**Subject: Dresden Station Units 2 and 3
 Quad-Cities Station Units 1 and 2
 Mark I Containment Plant Unique Analyses
 NRC Docket Nos. 50-237/249 and 50-254/265**

RESPONSE TO NRC QUESTIONS ON
MARK I SHORT TERM PROGRAM PLANT
UNIQUE ANALYSIS - DRESDEN UNITS 2 AND 3
(NRC DOCKET NUMBERS 50-237 AND 50-249)

RESPONSE TO NRC QUESTIONS ON
MARK I SHORT TERM PROGRAM PLANT
UNIQUE ANALYSIS - QUAD CITIES UNITS 1 AND 2
(NRC DOCKET NUMBERS 50-254 AND 50-265)

Figure 1

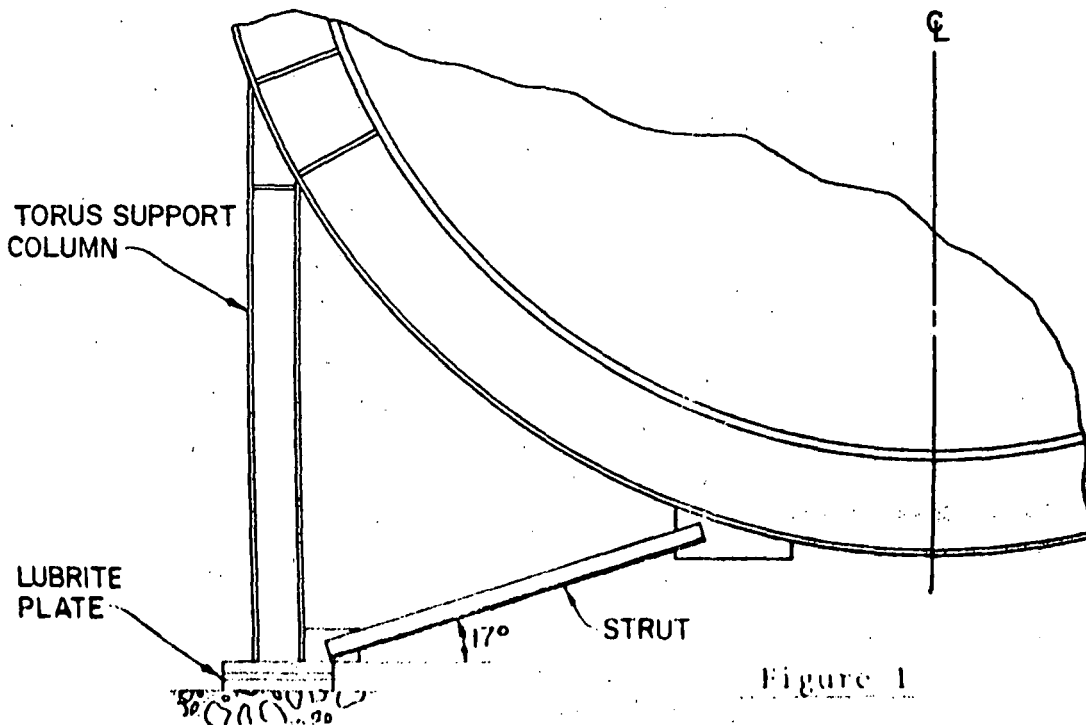
The strut between the base of the torus support columns and the lower portion of the torus shell has not been addressed in structural component evaluation reported in Reference 1 and 2 above. These components should be evaluated as part of the torus support structure.

Figure 1 below provides a general description of the subject strut and its connection to the torus support column and suppression chamber shell.

The 3-D model of the torus shell and its support system did not model the struts. However enough information is available from the 3-D model results to allow a separate evaluation of the struts. Such an evaluation has been conducted and the results are reported below.

For the evaluation of Item 2 above, it can be observed from Figure 1 that the maximum axial force that can exist in the strut is that which would cause a lateral displacement of the base of the torus support column. To determine an upper bound value for this axial load in the strut a conservatively high value for the coefficient of friction and the column load has been used. Using a value of 0.10 for the coefficient of friction and 845 kips for the column load (outside column, maximum submergence, horizontal and vertical seismic acting in compressive direction), the horizontal friction resistance is 85 kips. The upper bound value for strut axial load is therefore $85/\cos 17^\circ = 89$ kips.

The "code allowable" axial compression and tension force and the "ultimate capacity" axial compression and tension force for the strut have been calculated for comparison with the 89 kips computed above. The code allowable axial compressive load is 110 kips and is controlled by strut buckling considerations. The code allowable axial tension load in the strut is 111 kips and is controlled by the connection of the strut to the base of the torus support column. The ultimate capacity value for the tension and compression force in the strut is 251 kips and is controlled by the connection of the strut to the column base. Based on the above it can be concluded the axial forces in the strut will not exceed code allowables during the pool swell transient.

To answer the question posed in Item 3 above, the horizontal and vertical displacements at the point that the strut attaches to the shell have been extracted from the 3-D analysis results. It has been determined that these displacements are such that the strut will impose a lateral displacement at the base of the column. The maximum displacement of the base of the column occurs for the inside torus support column. This horizontal displacement of 0.067 inches results from a downward displacement of the strut-to-shell attachment point of 0.114 inches with a corresponding horizontal displacement (radially inward toward the centerline of the drywell) of 0.032 inches. The 0.067 inch lateral displacement results in a maximum bending moment in the torus support column of 420 in-kips. As reported

In summary; the strut has been evaluated for the effects of pool swell loads on the torus shell and it has been determined that forces in the strut and its connections will remain within code allowables. The effects of strut forces on the torus support columns are insignificant. Therefore the strength ratios and conclusions reported in References 1 and 2 remain unchanged.
